**Quality Audit Response Document**  
**Proposed Residential Development**  
**Drumlark, Co. Cavan**

## QUALITY AUDIT RESPONSE DOCUMENT

### PROPOSED RESIDENTIAL DEVELOPMENT, DRUMLARK, CO. CAVAN

**Stage 1 Quality Audit**

### 6.2 Issue

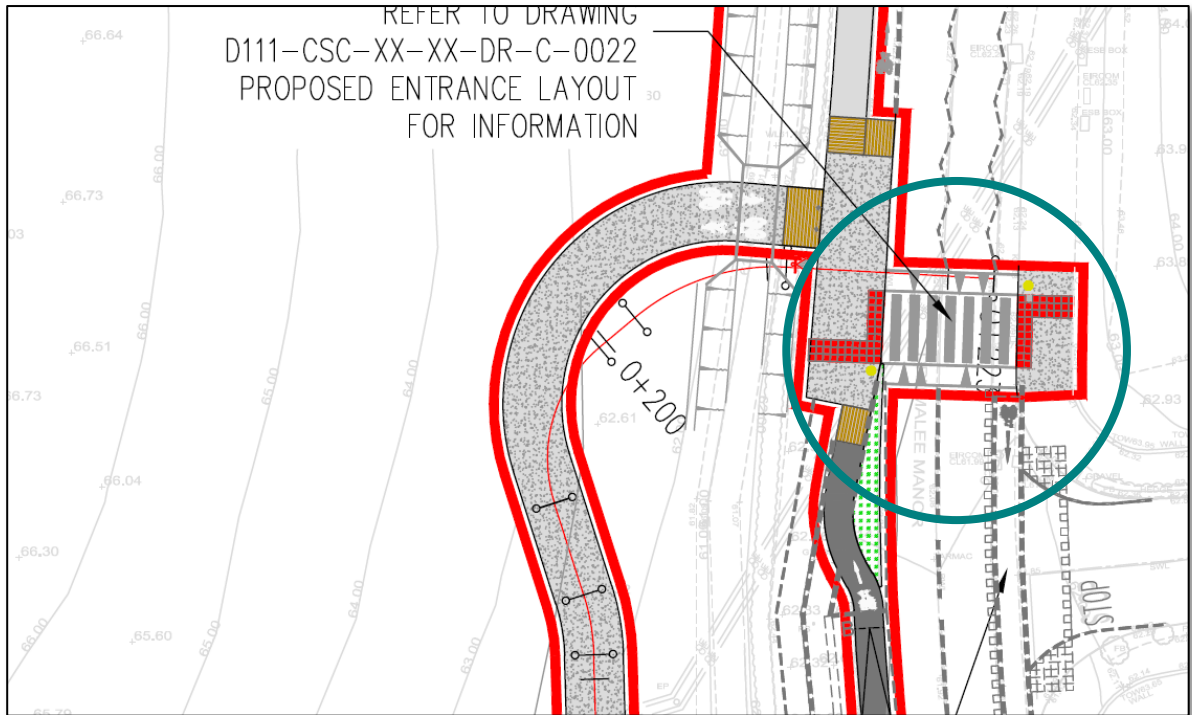
Tactile paving is not shown to be provided on the east side of the proposed Zebra crossing beside the access to The Moorings to enable a visually impaired user to differentiate between the footway and the cycleway.

Provide Corduroy tactile paving at the interfaces between the shared area and the footway and cycleway.

Corduroy tactile paving shall be provided at the interfaces between the shared surface area and the footway and cycleway. Refer to drawing **D111-CSC-XX-XX-DR-C-0025** for further details.

**6.3 Issue**

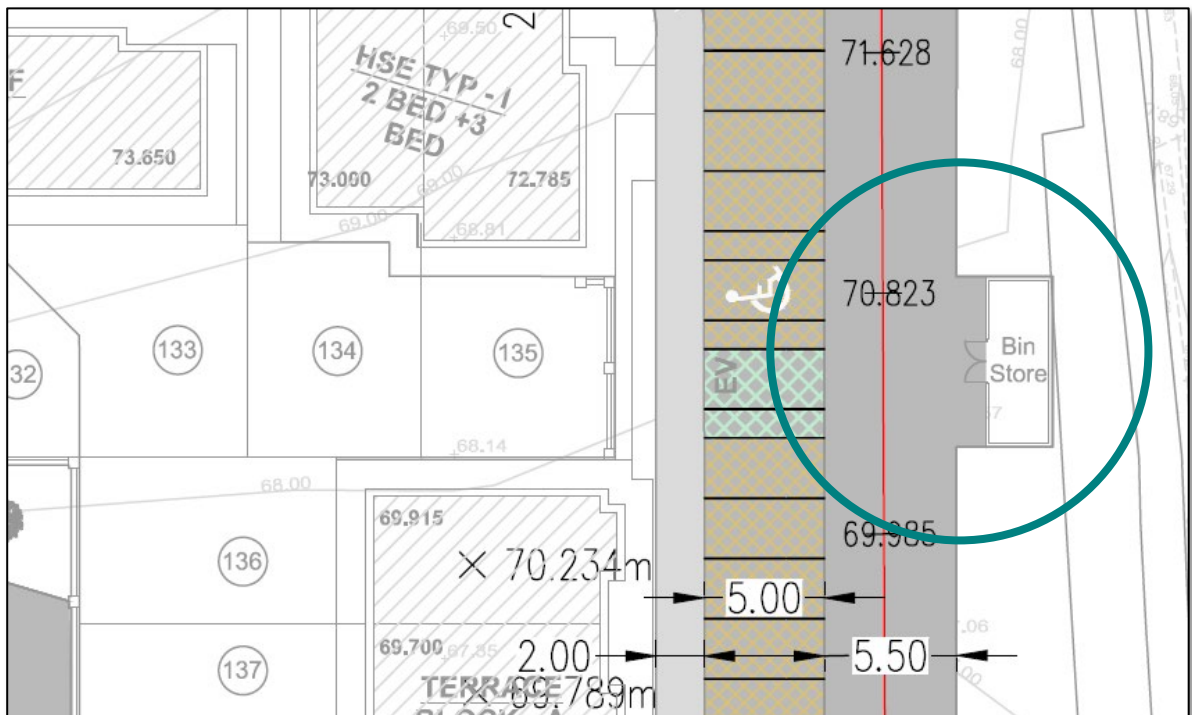
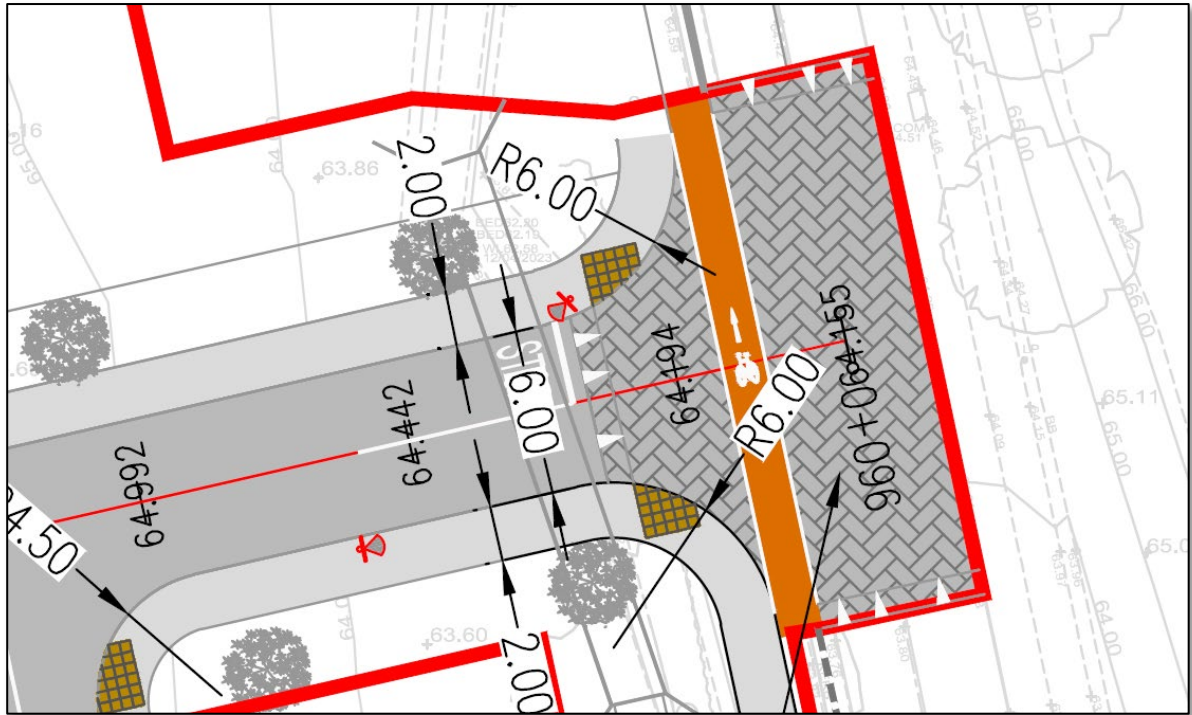
There is no pedestrian crossing or footpath provided to the bin storage facility provided at the south side of the development.

Ensure adequate facilities are provided for pedestrians to access the bin storage facility.

Adequate facilities are provided for pedestrians to access the bin storage facility. Refer to drawing **D111-CSC-XX-XX-DR-C-0025** for further details.

### 8.1 Issue

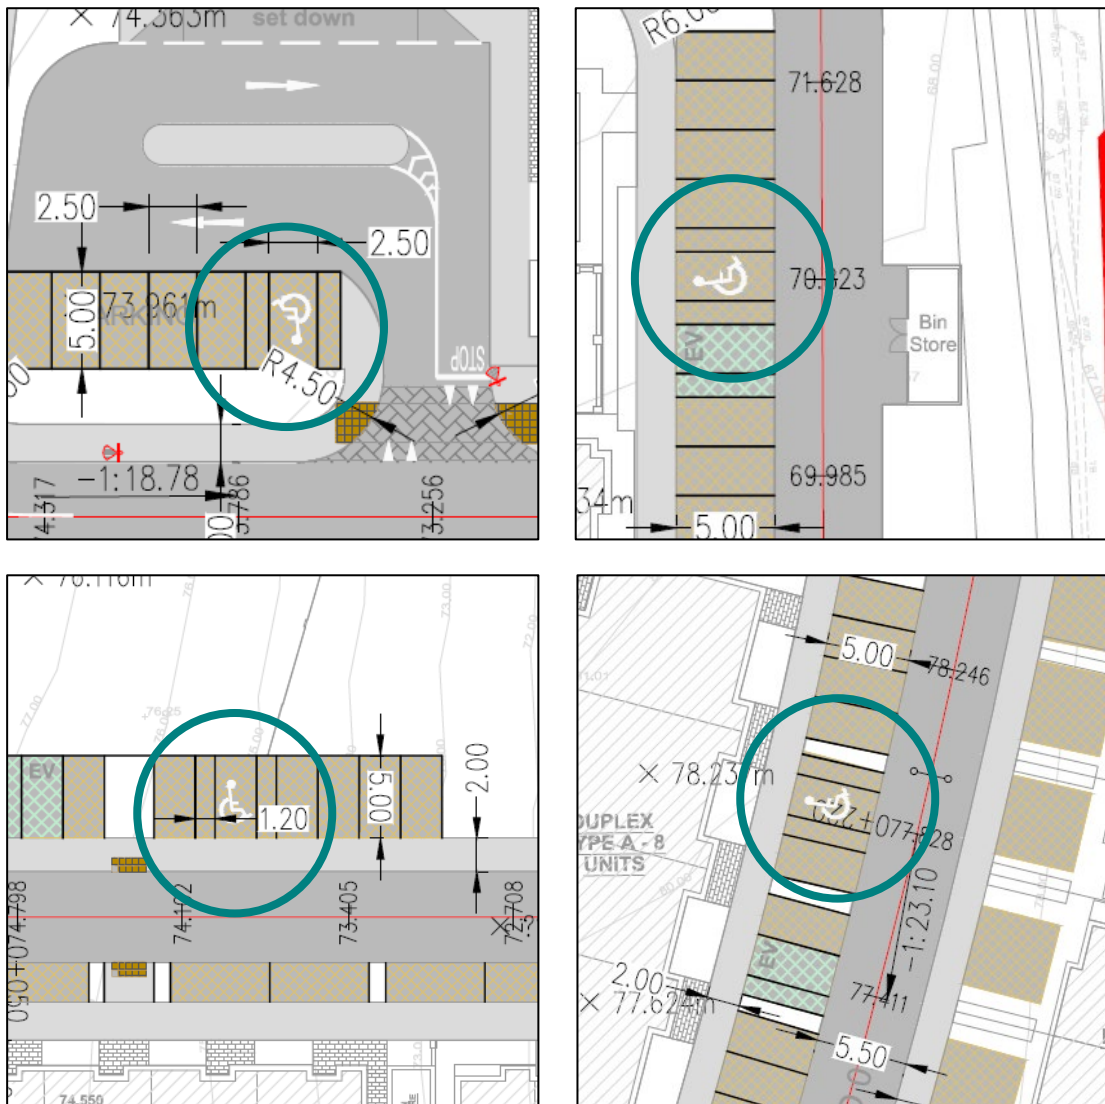
Accessible parking spaces are provided within the residential development; however, dropped kerbs or tactile paving are not shown to be provided to enable a mobility impaired pedestrian to access with ease the footpath adjacent to the accessible parking space.

Dropped kerbs and tactile paving shall be provided to enable mobility impaired pedestrians to directly access the adjacent footpath. Please refer to CS Consulting drawing no. **D111-CSC-XX-XX-DR-C-0025** for details.

### 8.3 **Issue**

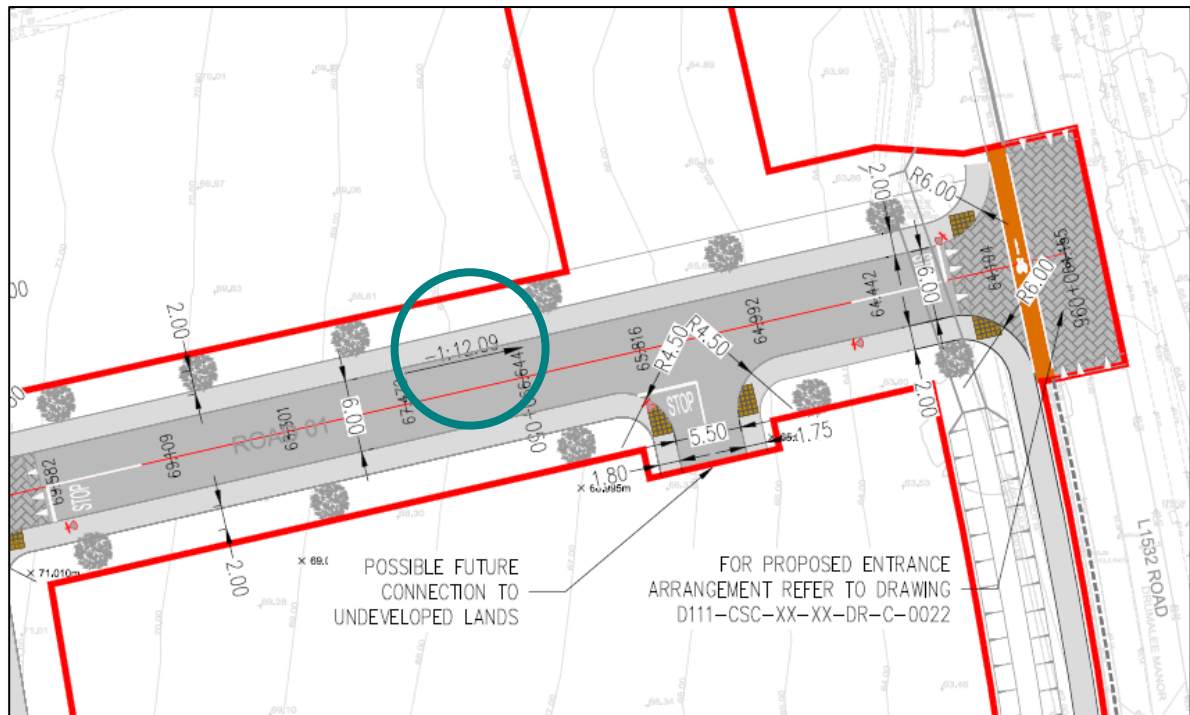
The footways along the access road to the development have a longitudinal gradient of 1 in 12, steeper than is adequate for universal access. An alternative pedestrian route is shown to be provided for pedestrian and cyclists; however, the gradients of the shared path are not indicated on the drawing. If they are too steep universal access may be restricted.

Ensure that the slopes of the shared path are not so steep as to constrain universal access, and that adequate dwell areas are provided.

The gradient of the proposed shared surface shall be 5%, and this shared surface is designed in accordance with Cycle Design Manual 2023. Please refer to CS Consulting Drawing no. **D111-CSC-XX-XX-DR-C-0025** for further details.

Architect	Michael Fitzpatrick (MFA)
Project	Drumclark Development Co. Cavan
Title	Proposed Road Layout
Dwg. No.	D111-CSC-XX-XX-DR-C-0001
Date	June 2023
Drn. by	SC
Chkd. by	JF
Apprv. by	NB
Scale	1:8500 @ A1
Revision	<b>P4</b>

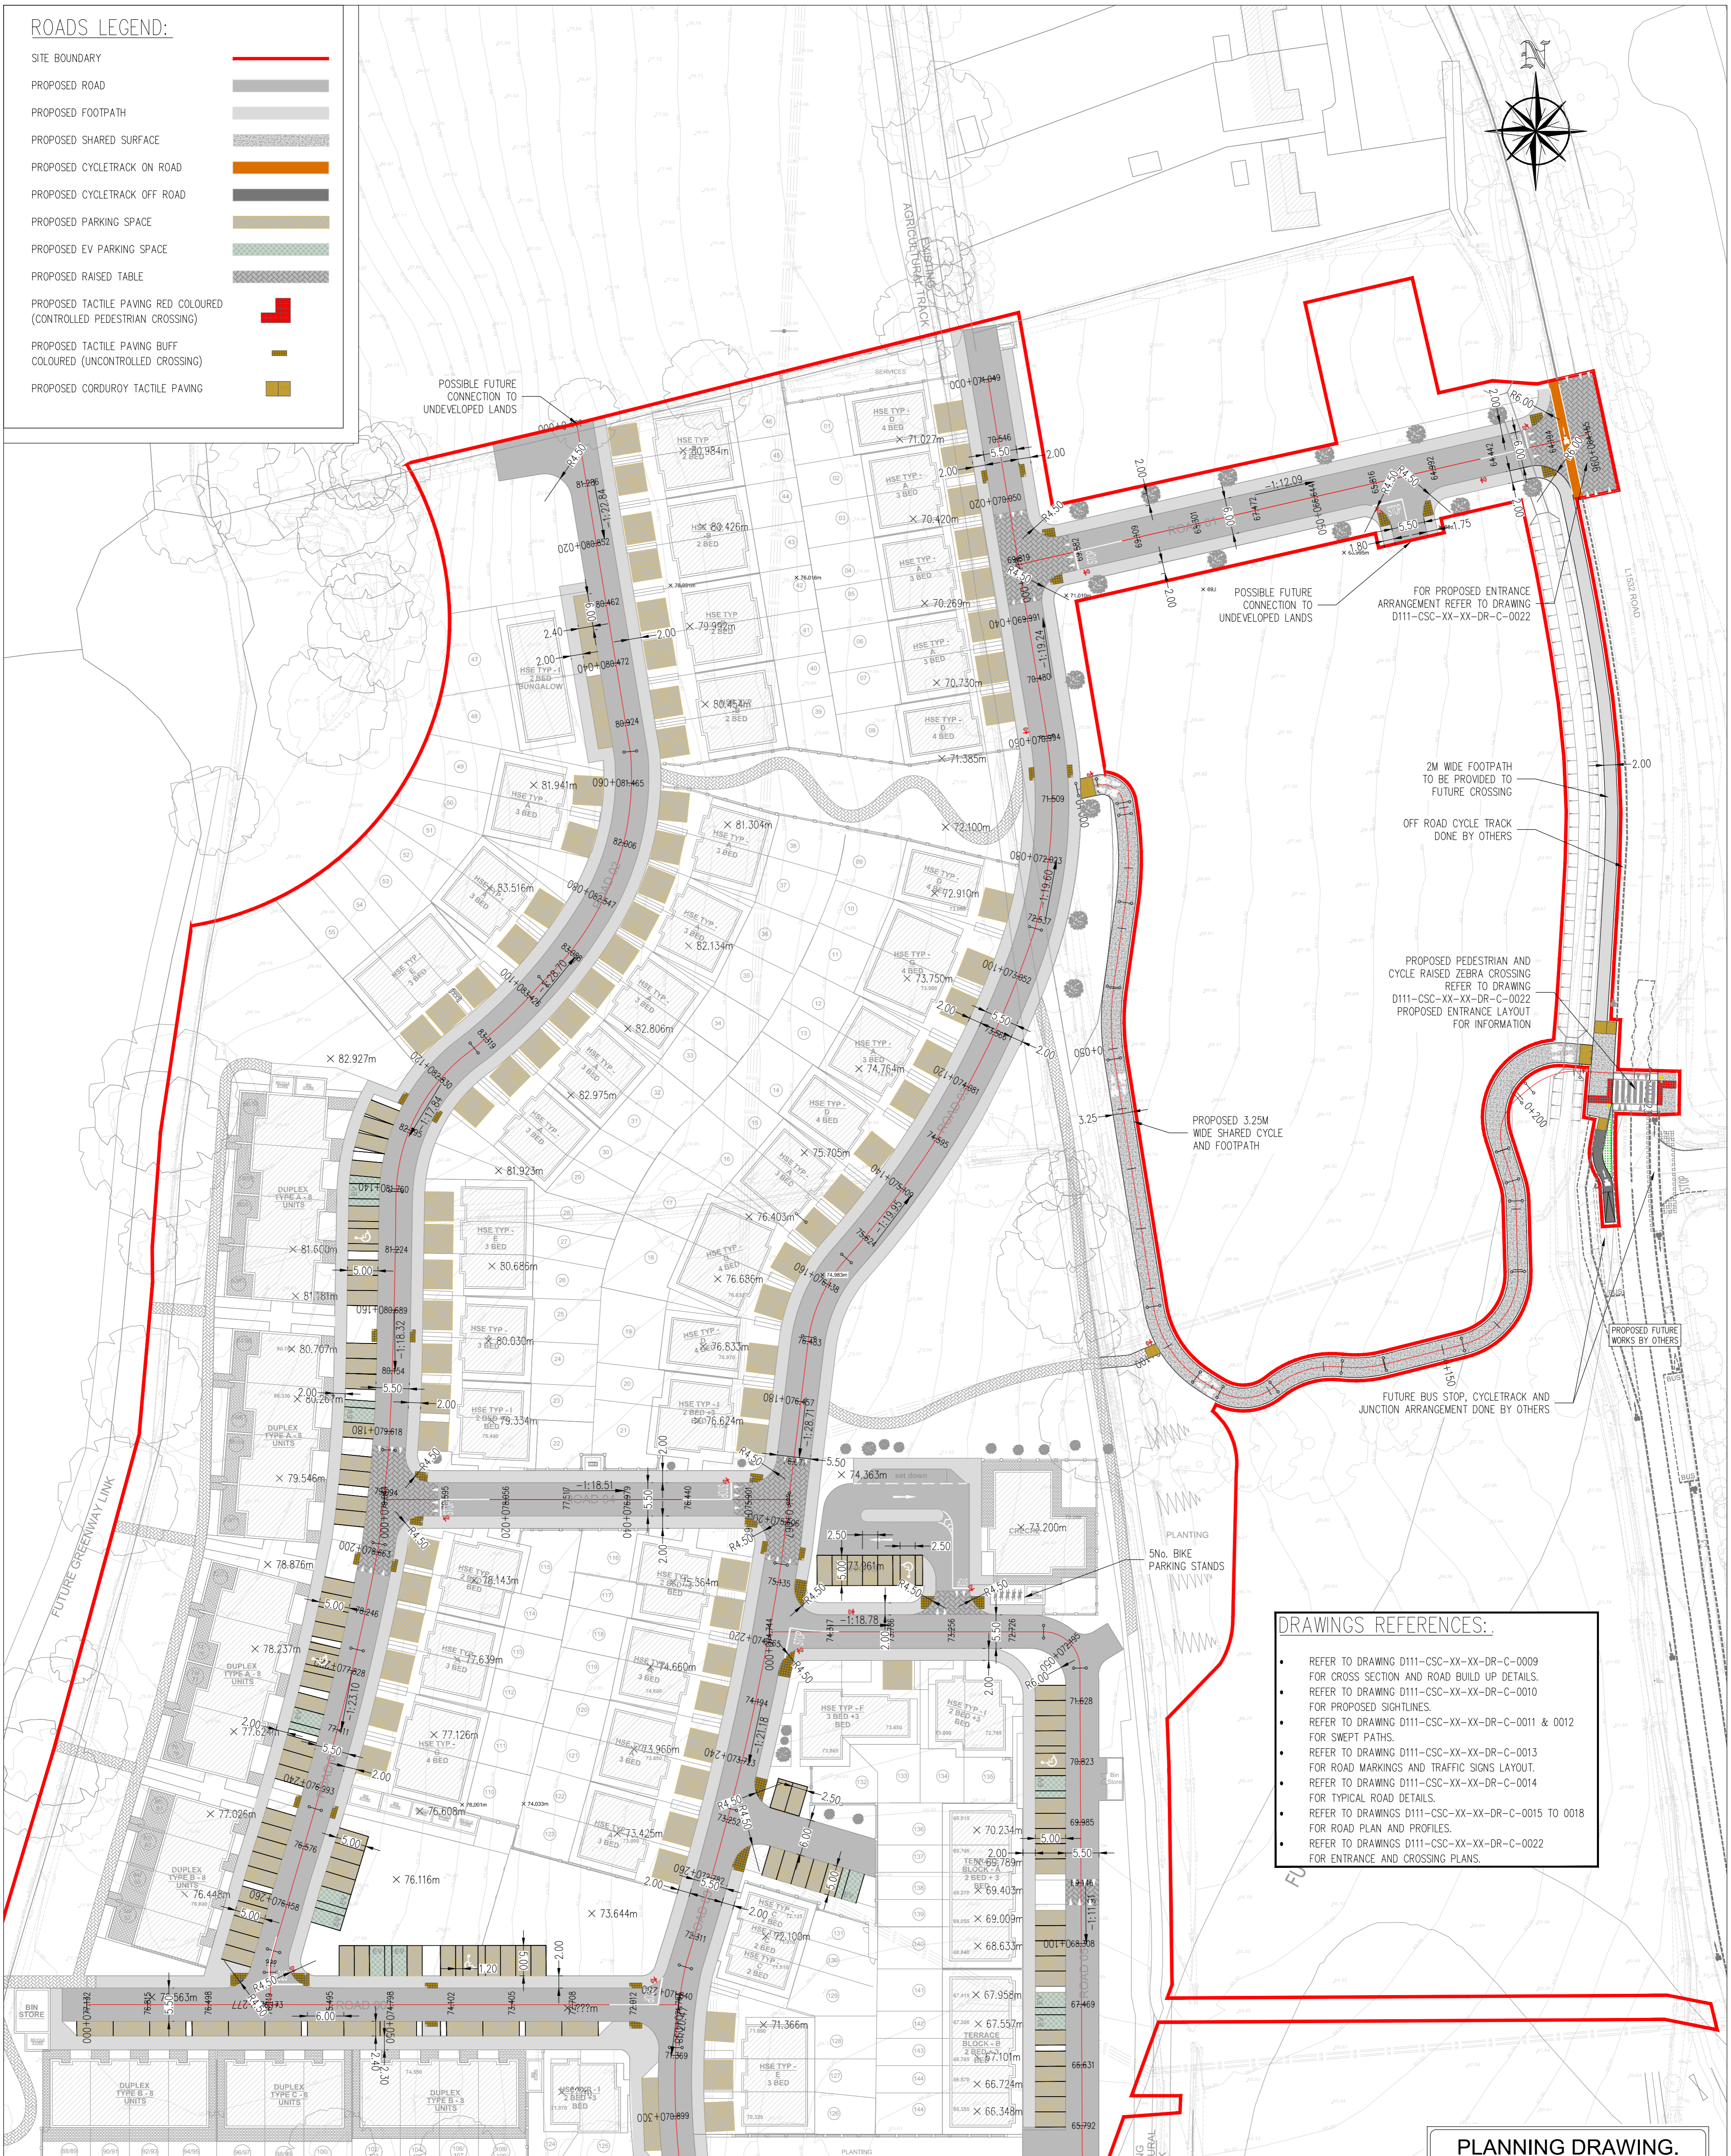
Some of the roads within the development may be steeper than is adequate for universal access. If they are too steep universal access may be restricted.

Ensure that each dwelling can be accessed via paths that are not so steep as to constrain universal access, and that adequate dwell areas are available.

The road levels and scheme design levels have been modified to ensure each dwelling can be accessed via paths that are not so steep as to constrain universal access. Please refer to CS Consulting Drawing no. **D111-CSC-XX-XX-DR-C-0001** for further details.
